DATE: 15 May 1953

ADDENDA

INSTRUCTION BOOK FOR RADIO STATION RS-6

Serial Numbers: 33 and higher

FIGURE 18. TRANSMITTER RT-6 SCHEMATIC DIAGRAM

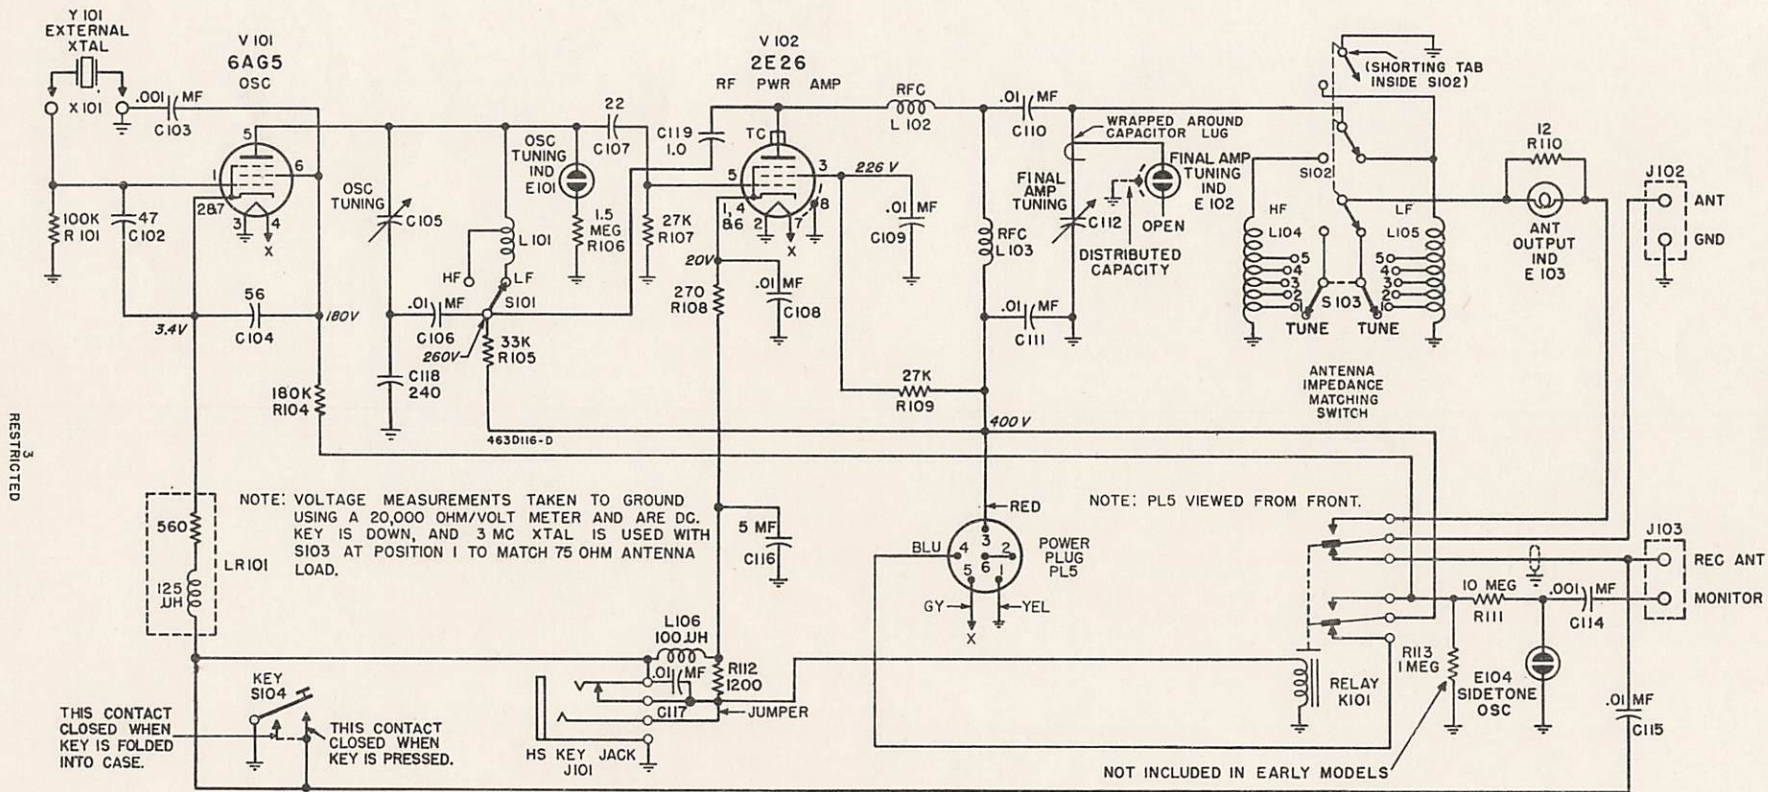
Page 24. Section II. Par. 28. Change "28. CIRCUIT DESCRIPTION - (See Schematic, Figure 18)", to read: 28. CIRCUIT DESCRIPTION - (See Figures 18 and 18.2).

FIG. 18.1 ANTENNA IMPEDANCE MATCHING SWITCH FOR TRANSMITTER RT-6 SERIAL NOS. 2001 TO 2614.

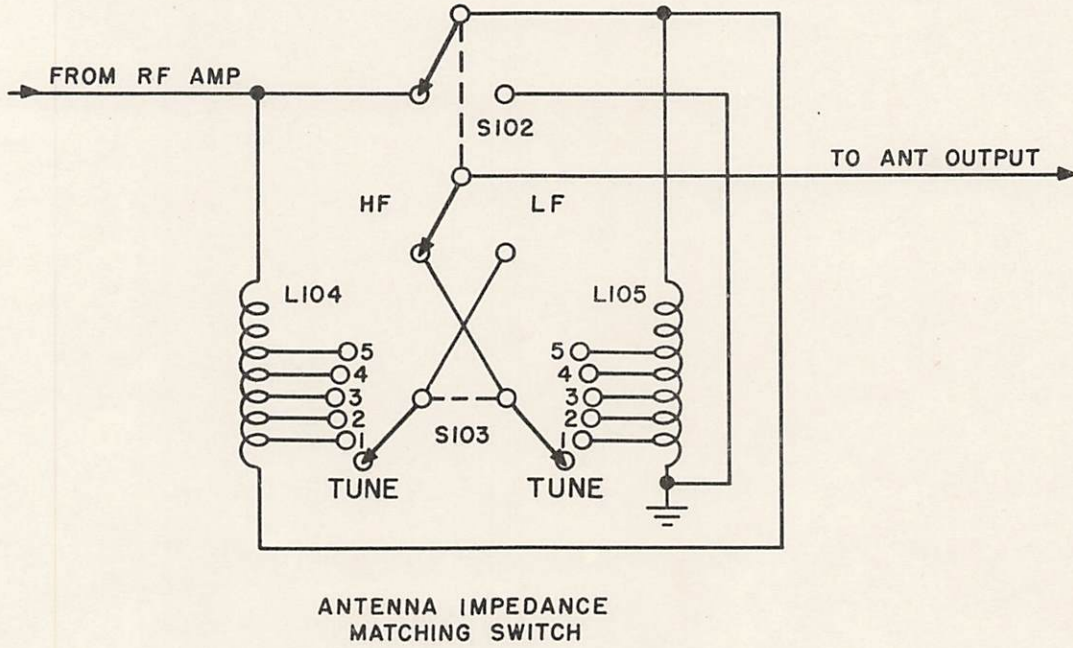
Figure 18.1 Antenna impedance matching switch for Transmitter RT-6 serial Nos. 2001 to 2614.

- d. A five position rotary switch (S103) provides a range of output impedances for maximum antenna output. Each position doubles the impedance of the previous position from 75 ohms on position 1 to 1200 ohms on position 5. S102, a slide switch (DPDT) shorts out coil L105 when in the HF (7.0 to 16.5 mc.) position. An incandescent bulb, E103, serves as an antenna current indicator.

FIG. 18.2 TRANSMITTER RT-6 NEUTRALIZATION CIRCUIT SIMPLIFIED DIAGRAM

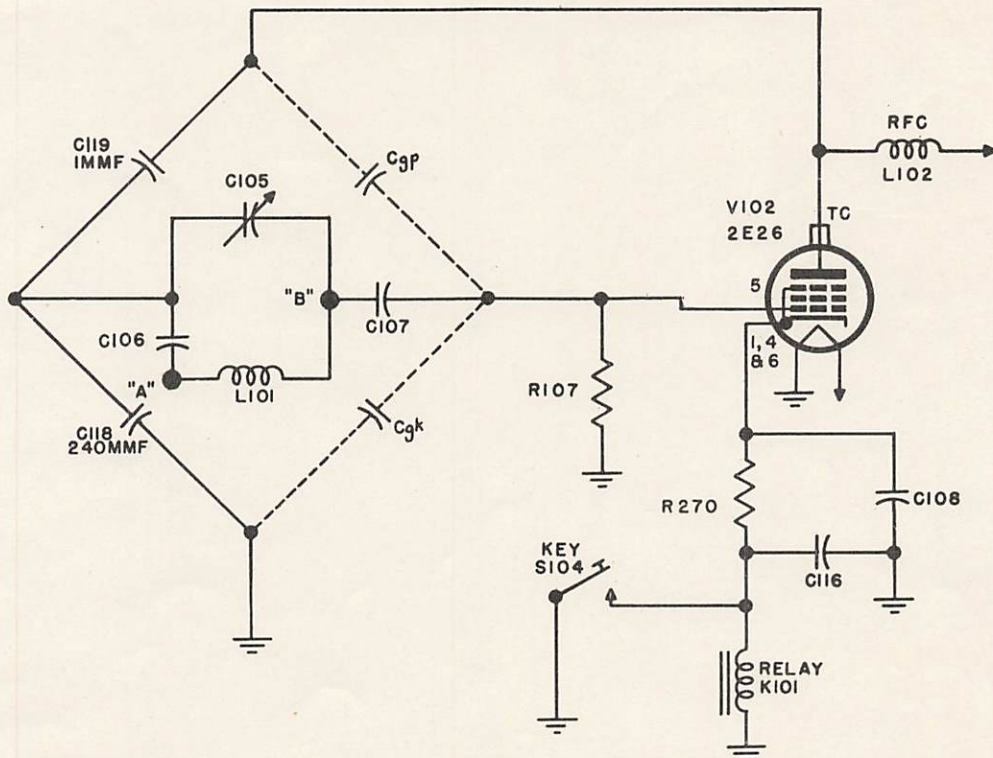
Figure 18.2 Transmitter RT-6 Neutralization circuit, Simplified Diagram.

- c. C118 and C119 are part of a grid neutralization network as shown in Fig. 18.2; Cgp represents the grid to plate capacitance and Cgk the grid to cathode capacitance of V102 (2E26). The "bridge" circuit is in balance when $\frac{C119}{C118} = \frac{Cgp}{Cgk}$.

This condition is approximated by the values of 240uuf for C118 and 1.0uuf for C119. This circuit is effective in the reduction of parasitic oscillation originating in the grid circuit of the final RF amplifier, and it normally is not frequency selective. C106 (.01uf) does not affect the parallel tuned circuit C105 and L101. The primary function of C106 is to keep B plus off the rotor of C105 and still provide a low impedance path for RF current. The oscillator plate voltage is applied to point "A". The plate of V101 (6AG5) connects to point "B" of Fig. 18.1. Radio frequency choke L102, in the plate circuit of V102 (2E26) is a parasitic suppressor. Regenerative feedback is further reduced by the use of a shielded lead from the REC ANT terminal on J103 to the relay K101. This shielded lead also prevents some of the transmitter noise from entering the receiver during break-in operation.
